**Conditions of development consent for the Sydney Metro Martin Place Station Precinct
SSD 9270 – North Site**

Condition B5, B6 and B7 discharge request #4 – Design excellence and design integrity review

Figure 1 Approved (top) and proposed (bottom) northern elevation

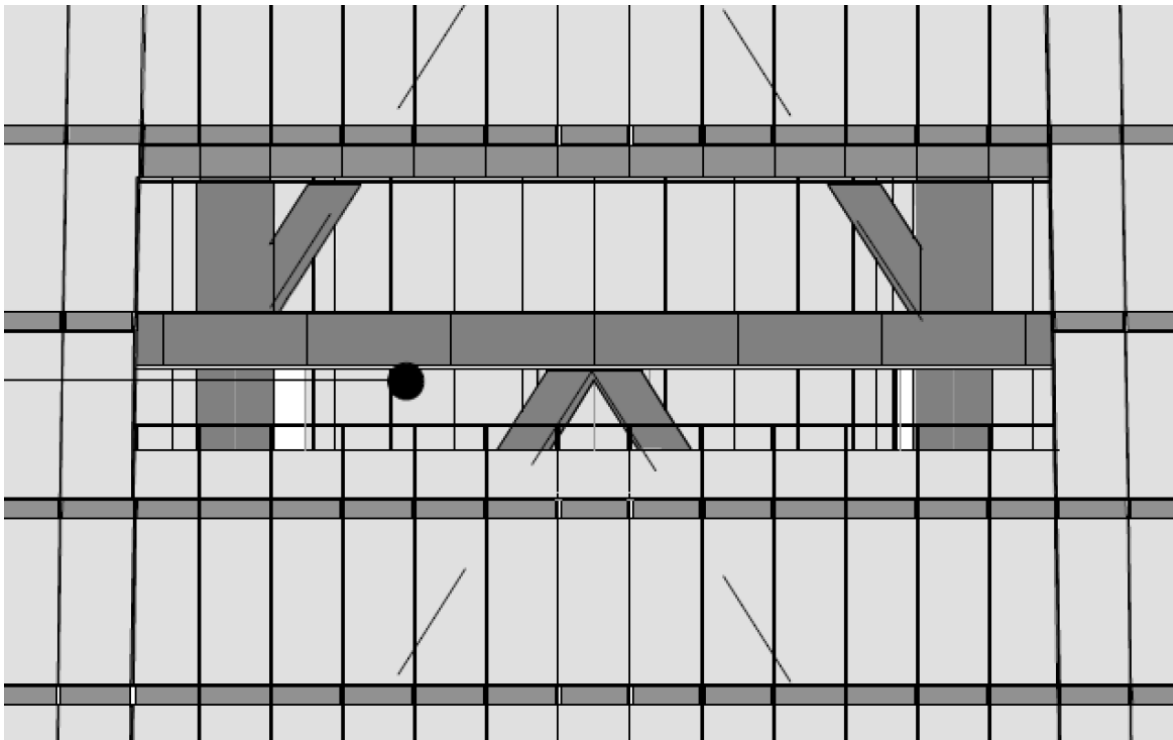
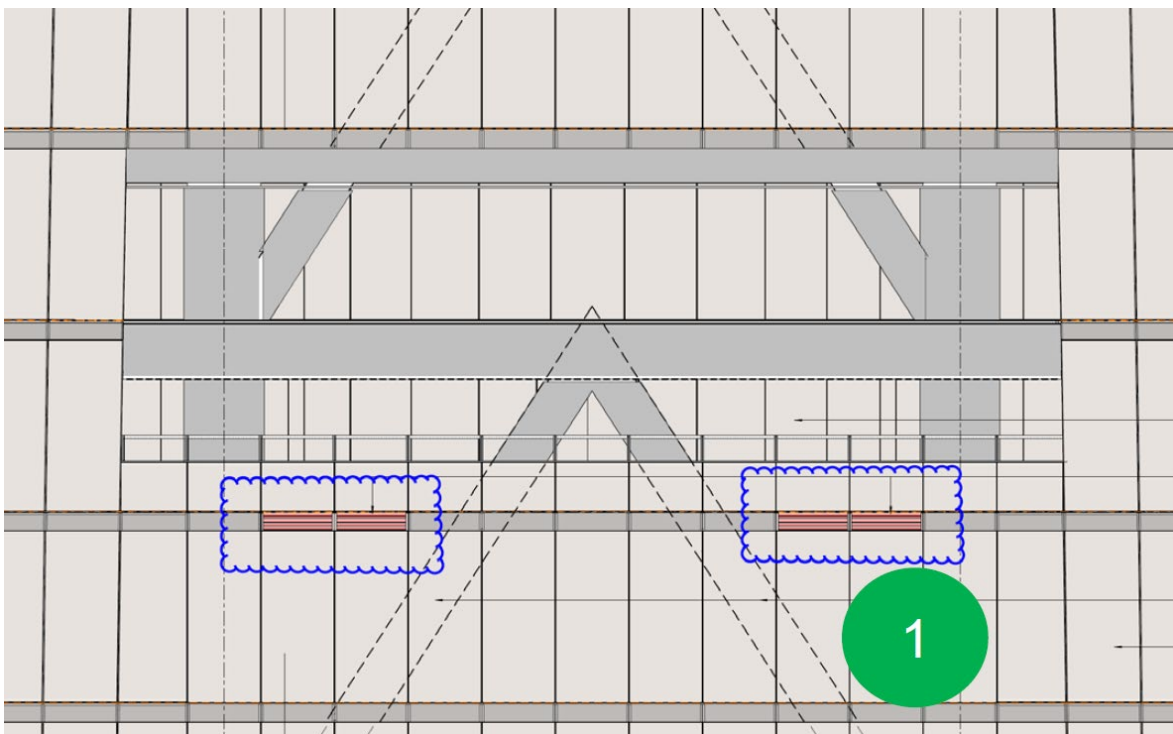
Accordingly, this letter is prepared in accordance with Condition B5 and sets out a proposed design change to the approved architectural drawings. The change relates to a kitchen exhaust discharge added to northern façade of the tower, on Level 10. The proposed louvres are small in nature and not overly distinguishable, being a minor detailed design element.

Extract from proposed northern elevation (with kitchen exhaust detail added)
